**SUBJECT:** Construction of traffic signal and associated street improvements at the intersection of Magnolia Avenue and Neece Street in the community of Home Gardens.

### ADDENDUM NUMBER 1

**MAGNOLIA AVENUE AND NEECE STREET  
TRAFFIC SIGNAL AND STREET IMPROVEMENT PROJECT**

**PROJECT NO. B6-0460**

**A – Western Municipal Water District- Standard No. W-0610  
Fire Hydrant**

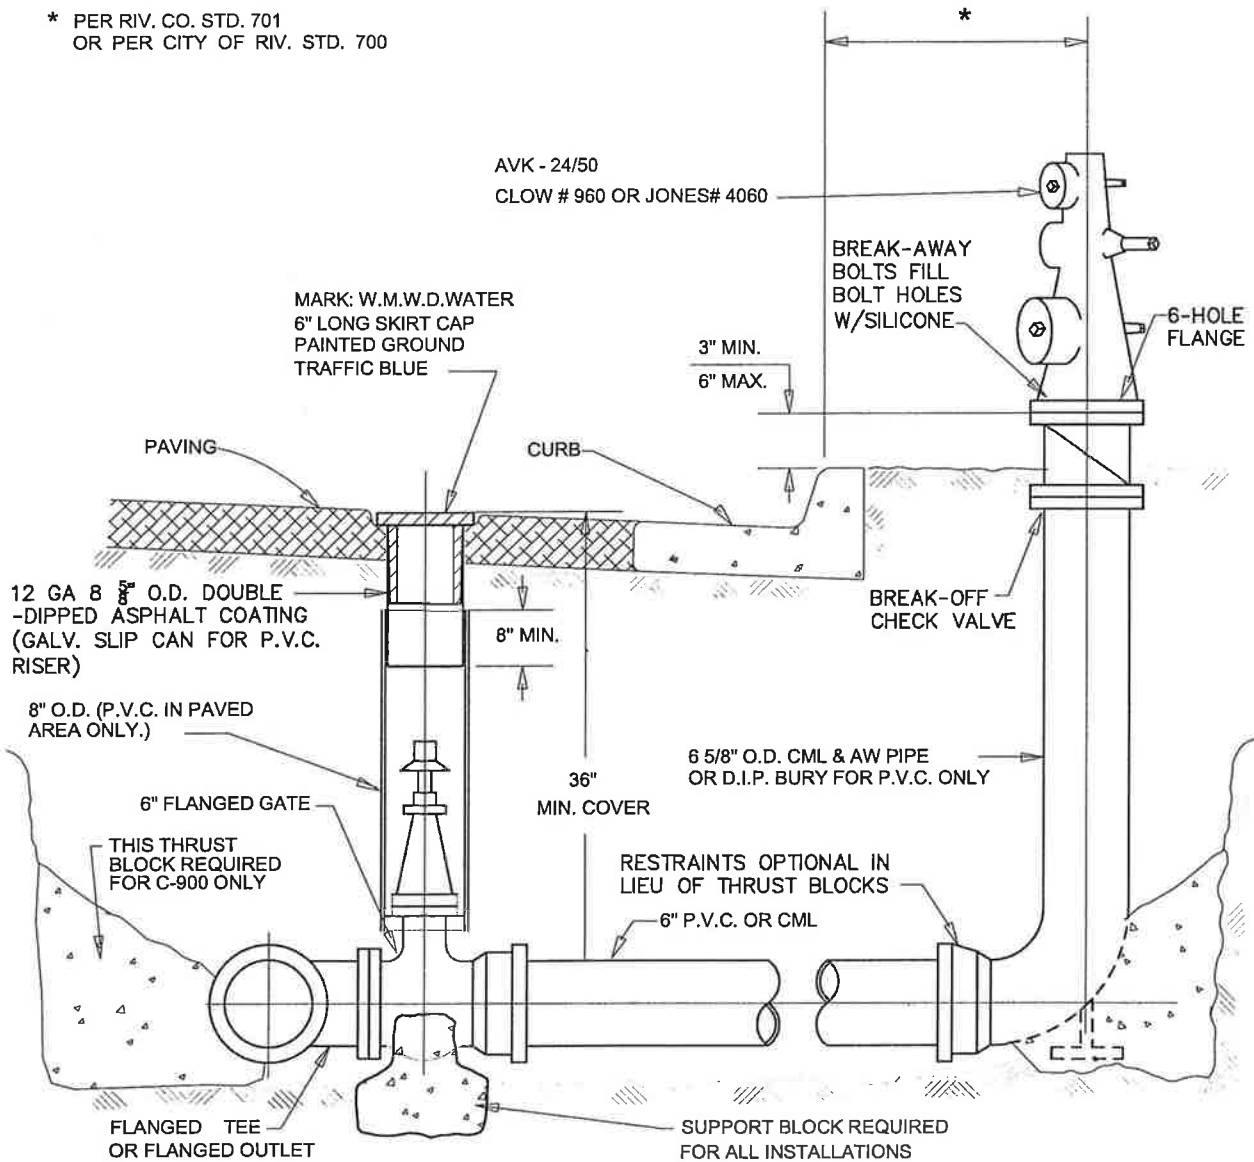
**Item 1: Relocate Fire Hydrant Revisions.** Refer to section "RELOCATE FIRE HYDRANT" on page 175. The first paragraph is deleted and replaced with the following:

Fire hydrant relocation/adjustment to grade shall conform to the plans and Standard Specifications of the Western Municipal Water District (WMWD) and as directed by the Engineer. All work shall be performed under the inspection of a representative of the Home Gardens County Water District. WMWD-Fire Hydrant Standard No. W-0610 is attached herewith as **Attachment "A"**.

**Item 3:**        **Construction Note 23.** Refer to plans, Construction Notes, the following construction note is revised and made part hereof.

**23**    **RELOCATE FIRE HYDRANT BEHIND NEW SIDEWALK PER WMWD  
STD. NO. W-0610.**

WMWD Standard No. W-0610 is added by **Attachment "A"** and made part hereof.
